U. S. NUCLEAR REGULATORY COMMISSION

Report No. 50-255/93020(DRS)

Facility Name: Palisades Nuclear Plant

Areas Inspected: Special, announced, team inspection of licensee activities relating to Summer 1993 refueling outage problems, and to plant restart preparations, including: the safety evaluation for the cycle 11 core reload, routine plant operations activities, the impact of the fuel lost from the damaged fuel assembly, the root cause evaluation for the stuck fuel assembly, the regulatory issues identified in the AIT report, and the September 9, 1993 public meeting.

Figure 1 - Revised L-assembly for Cycle 11

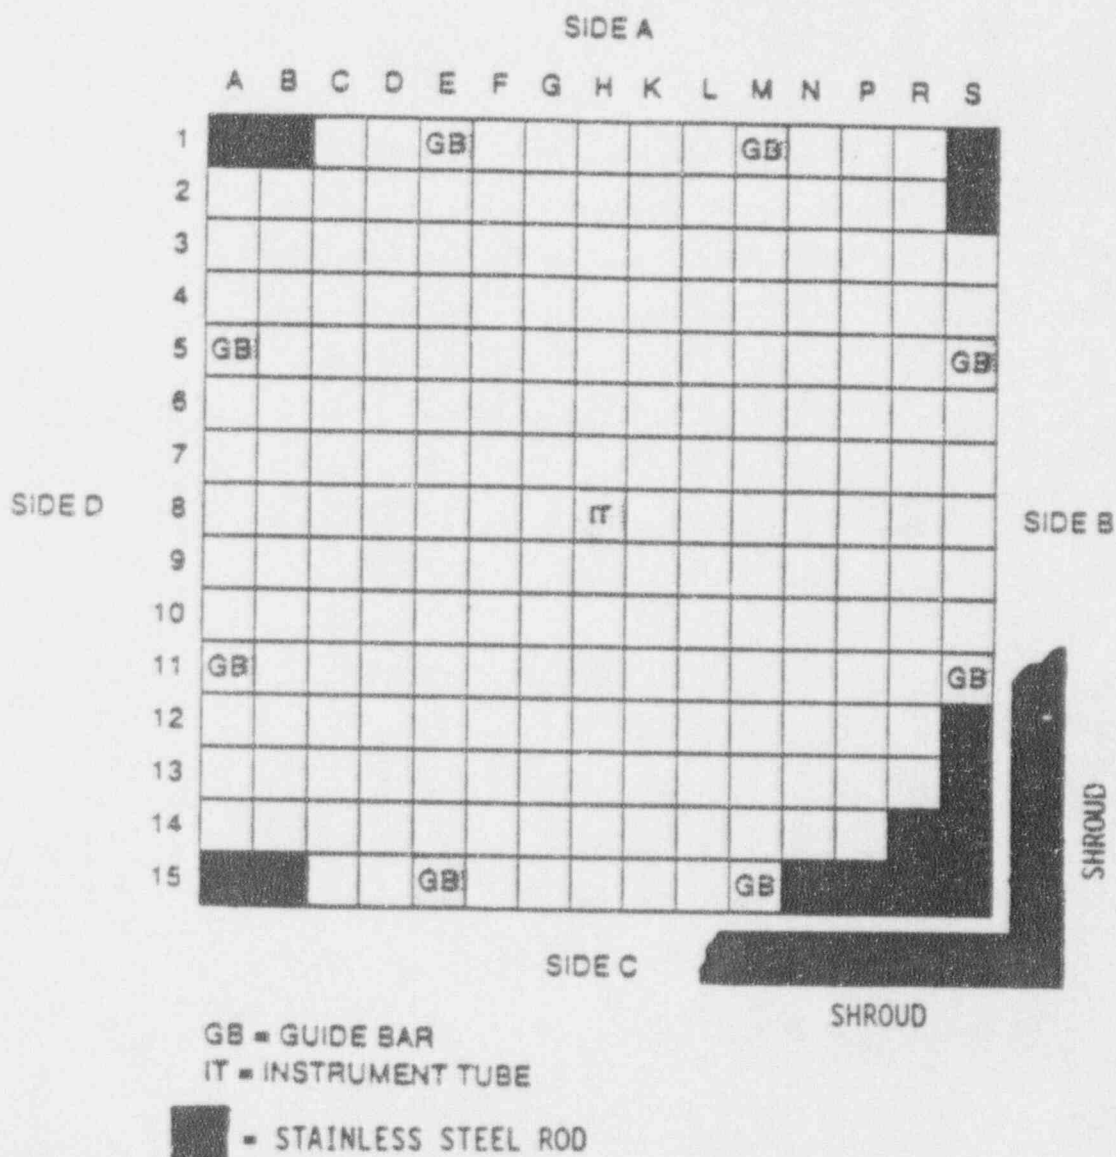
The M-assemblies, N-assemblies, O-assemblies, and SAN-assemblies have not been altered for the revised Cycle 11. The L-assemblies have been reconstituted for the revised Cycle 11 by replacing 14 fuel rods with 14 solid stainless steel rods. Eight stainless steel rods were placed in the corner of the fuel assembly in the shroud corner with the stainless steel rods placed from the guide bar to the corner plus the location next to the corner location as shown in Figure 1. Each remaining corner of the fuel assembly contains 2 stainless steel rods as shown in Figure 1.

The stainless steel rods are 0.437 inches in diameter while the fuel rods they replaced were 0.417 inches in diameter. The licensee proposed that the larger diameter rods will reduce the probability of fretting damage during Cycle 11 due to an estimated increase in spring force of 0.6 pounds. The licensee proposed that the corners with 2 stainless steel rods will be less likely to fret and that the load on adjacent fuel rods will be symmetrically increased, decreasing the probability of fretting on the adjacent fuel rods.

The stainless steel rods in the reconstituted L assemblies are slightly larger in diameter than the fuel rods. The larger stainless steel rods in the corner will exert more force on the lantern spring, thereby tightening up the adjacent fuel rods. This results in higher spring force on fuel rods to compensate the spring relaxation during irradiation. The fuel vendor's analysis and testing results confirmed that there was higher spring force on the adjacent fuel rods. Since SPC has confirmed that the bimetallic spring relaxed as expected, the use of larger stainless steel rods tends to reduce the potential for fretting between the fuel rods and spacer springs. Thus, the team considered the use of larger stainless steel rods acceptable.

Figure 2 - Revised Cycle 11 Core Design

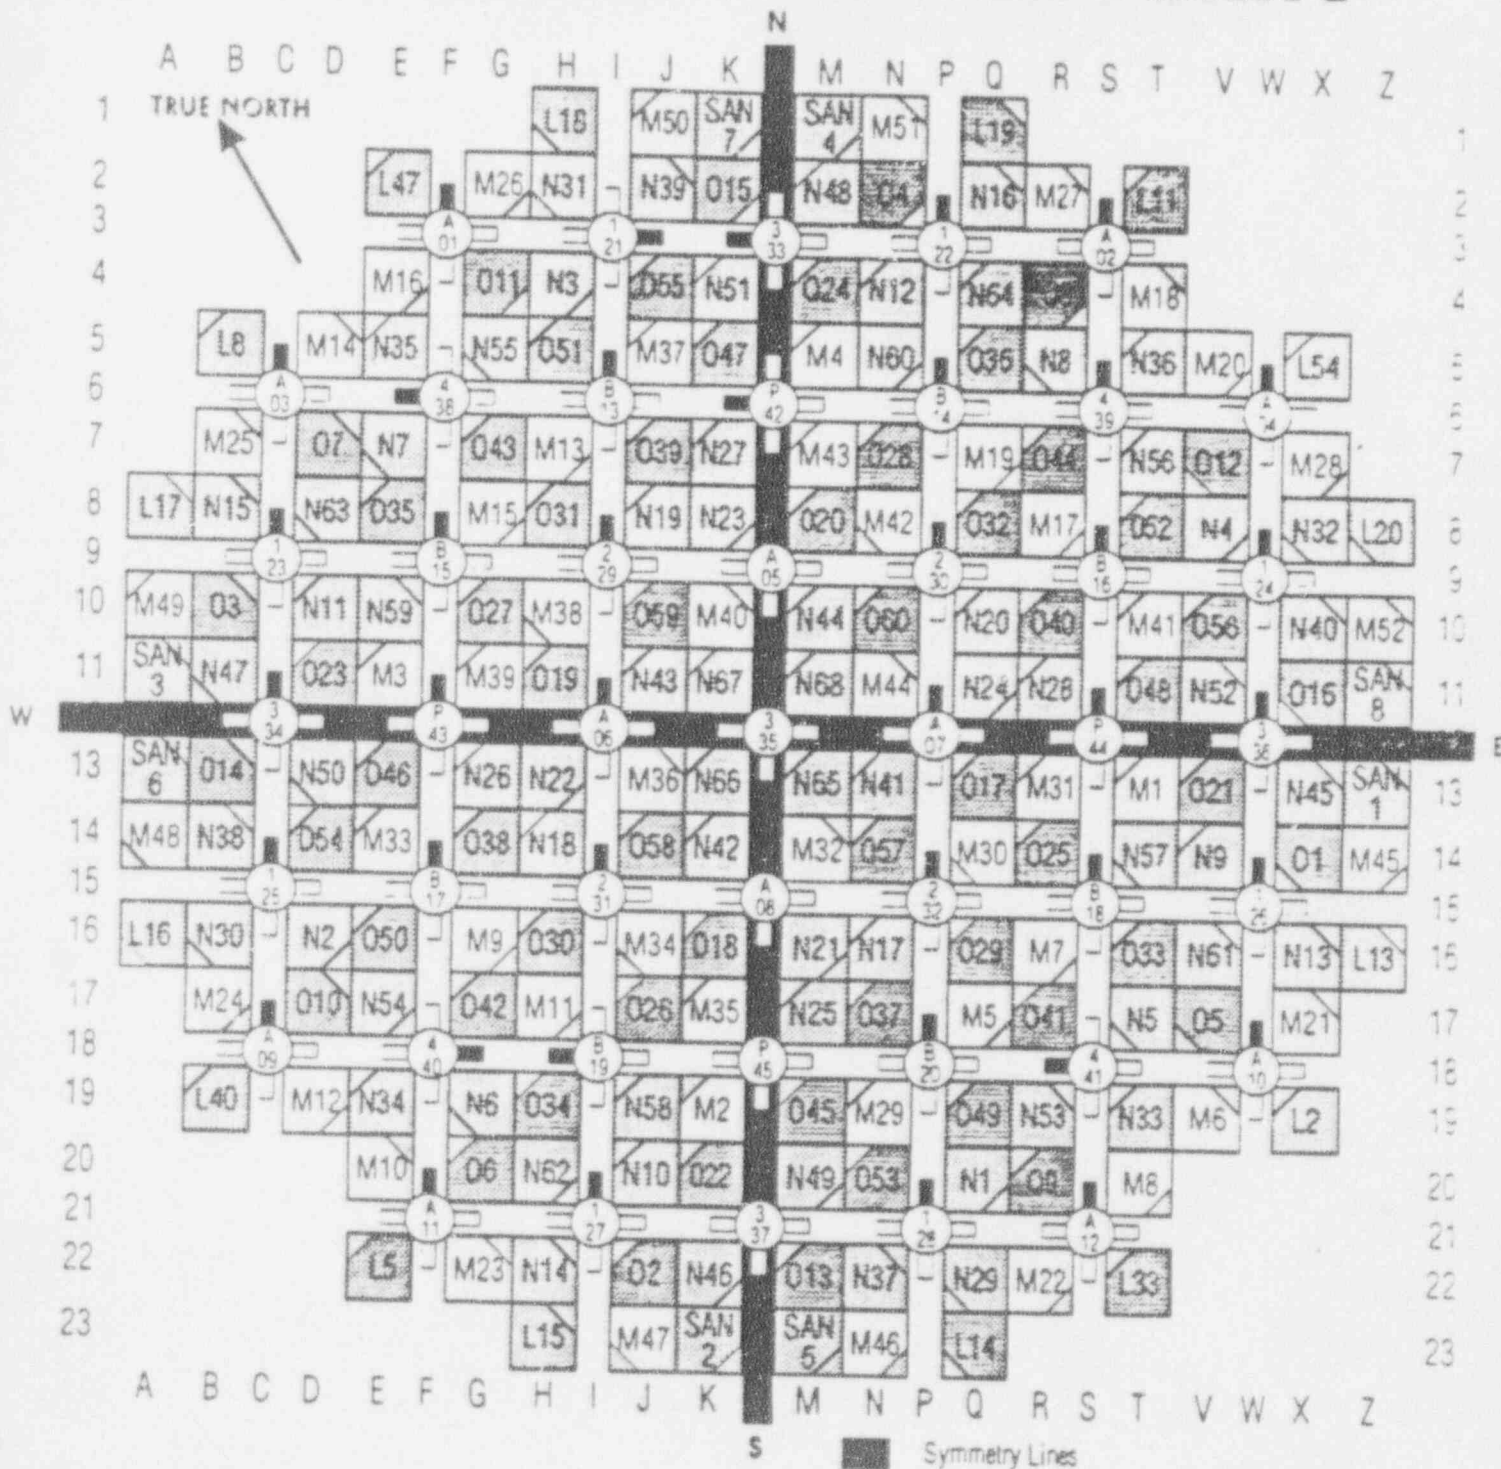
The revised Cycle 11 core contains 52 twice-burned M-assemblies, 68 once-burned N-assemblies, 60 fresh O-assemblies, 8 once-burned N Shield Assemblies (SAN), and 16 modified thrice-burned L-assemblies with 14 solid stainless steel rods inserted in the assembly corners. The difference between the revised and the original Cycle 11 core designs is the 16 reconstituted L-assemblies and the relocation of the selected M and N assemblies (20 assemblies in each batch). Figure 2 shows the revised Cycle 11 core design.

For fluence reduction purposes, the revised Cycle 11 core is a low radial leakage core incorporating 8 SAN assemblies in the flat peripheral regions and 16 reconstituted L-assemblies in the core corner locations. A higher initial reactor coolant boron concentration is needed to offset the additional reactivity in the revised Cycle 11 because of the revised L-assemblies (which are more reactive as compared to the I-assemblies), because the O-assemblies have enrichment higher than previous fuel assemblies, and because of less gadolinia used in Cycle 11 fuels as compared to previous cycles.
